MANDATORY**SERVICE BULLETIN**

DATE: December 1, 1997 Service Bulletin No. 505B (Supersedes
Service Bulletin No. 505A) Engineering
Aspects are FAA Approved

SUBJECT: Inspection of Crankshaft I.D. for Corrosion

Figure 1. Area to be Inspected

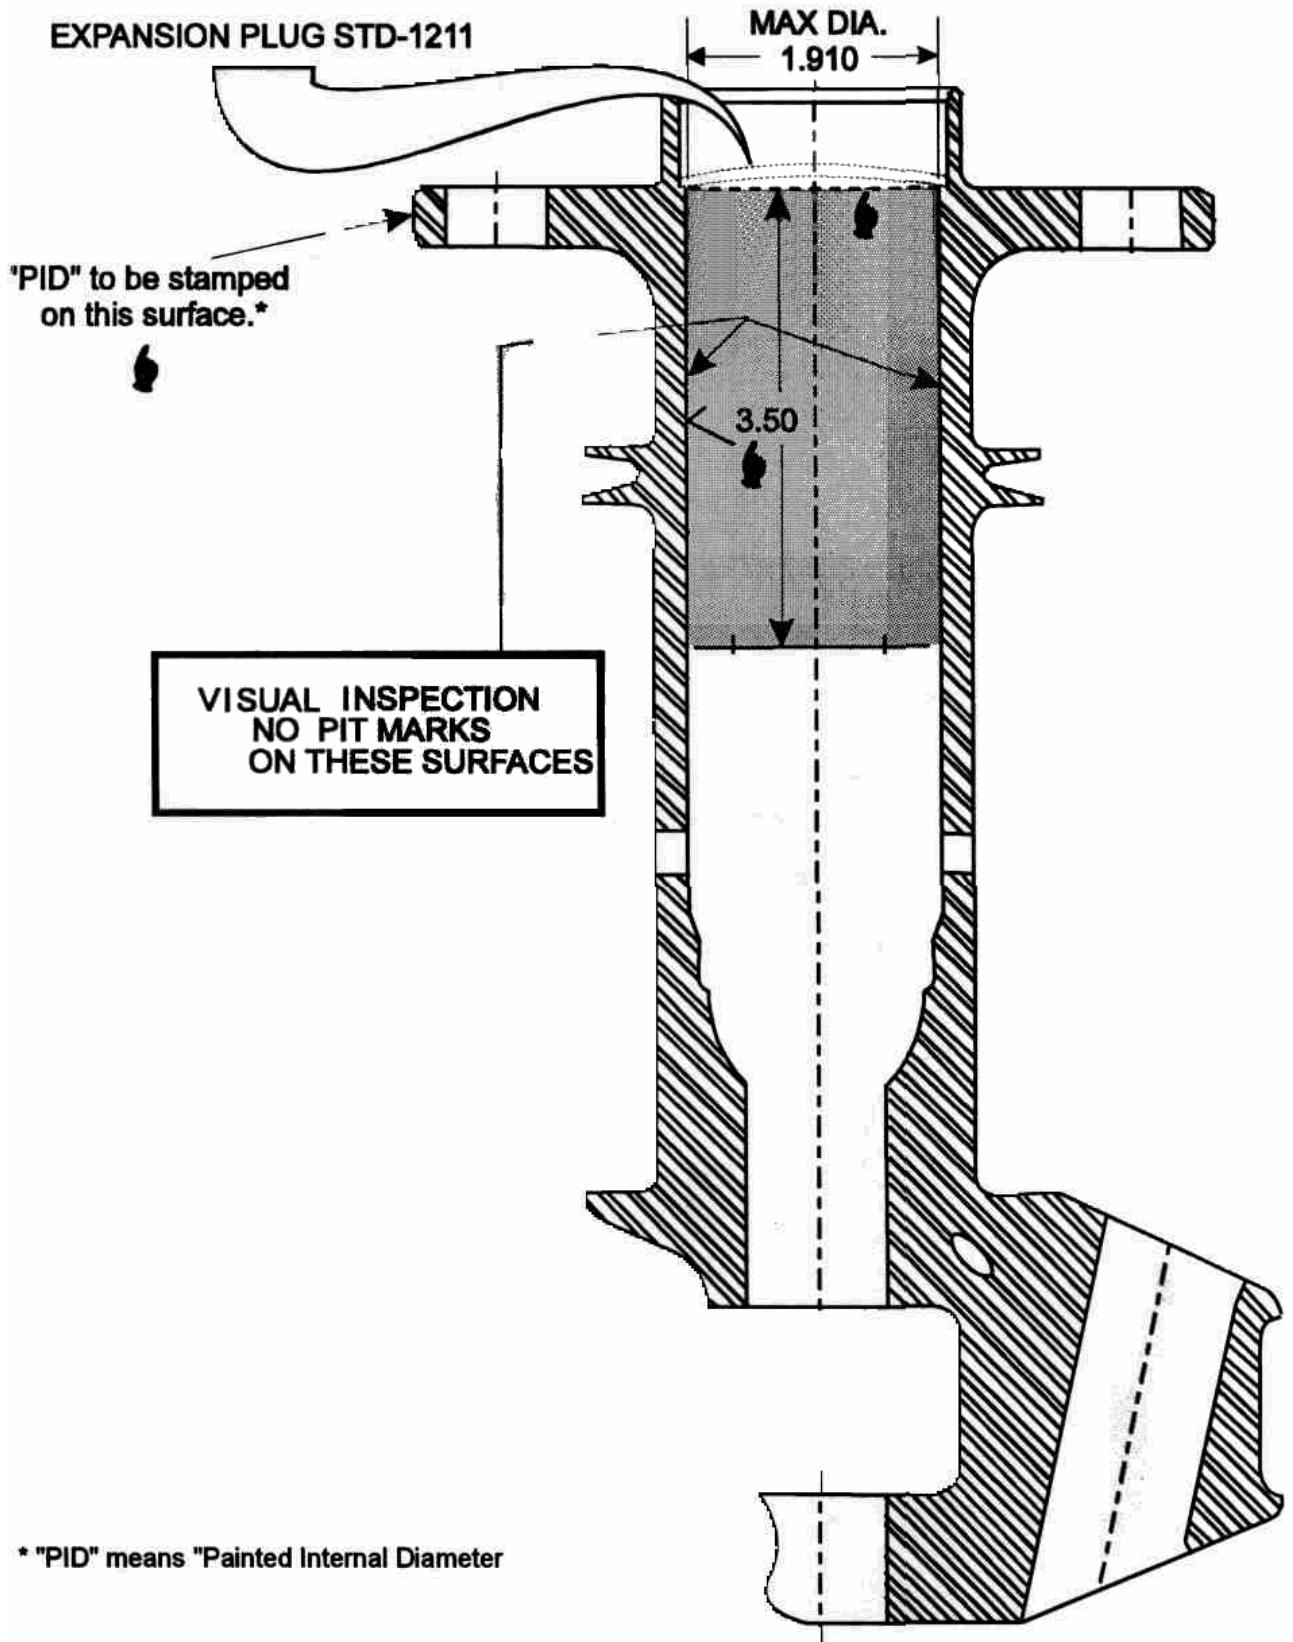
TIME OF COMPLIANCE: **Uncoated Crankshafts (no "PID" stamped on flange OD, see Figure 1)**

- a. Remove the propeller in accordance with the manufacturer's instructions.
- b. Remove expansion plug (P/N STD-1211) (if installed) from end of crankshaft by piercing a 1/8" to 3/16" hole in center of plug.
- c. Measuring in from the crankshaft end, clean the first 3.50 inches of the inside crankshaft wall behind the expansion plug seat.
- d. Remove surface corrosion using a suitable tool which will follow the existing contour of the I.D. and fine abrasive cloth (see Figure 1). Prior to removing the corrosion, precaution must be taken to ensure that the material removed cannot contaminate the engine.

CAUTION
SURFACE CORROSION MUST BE REMOVED UNIFORMLY FROM THE CRANKSHAFT I.D. BUT THE I.D. CANNOT EXCEED 1.910 INCHES.

- e. Make a visual inspection from the crankshaft flange inward using a flashlight and magnifying glass (power 4x). A small, right angle, dental examination mirror might be helpful. The above defined area should be clear of pit marks and corrosion.
- f. If during visual inspection any pitting resulting from corrosion is found, the crankshaft must be removed from service immediately or subjected to FPI according to Section II of this Service Bulletin on page 3. Removal of corrosion results in a clean surface that may have an irregular appearance indicated by slight wavi-ness. This condition is deemed acceptable provided the maximum allowable diameter has not be exceeded. Pitting is characterized by holes or fissures of indeterminate depth and direction.
